TECHNICAL SERVICE BULLETIN

NO. 73-A-5

THROTTLE CABLE

MGB & MGB/GT

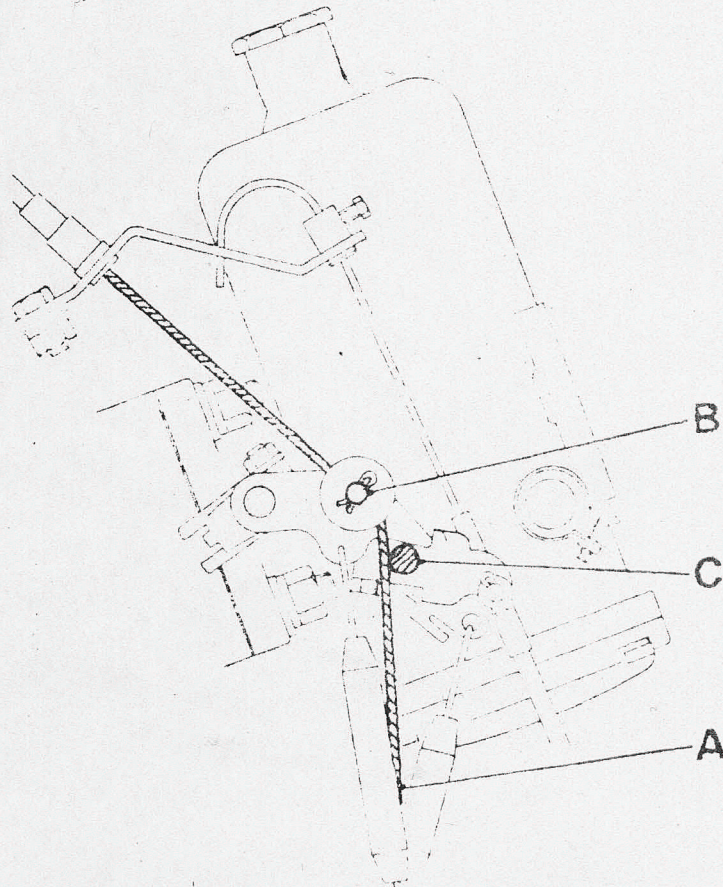
When replacing carburetors on these models, insure that the free end (A) of the throttle cable below the throttle cable trunion (B) cannot interfere with the free operation of the throttle; it is essential that it be routed on the engine side of the choke lever spindle (C).
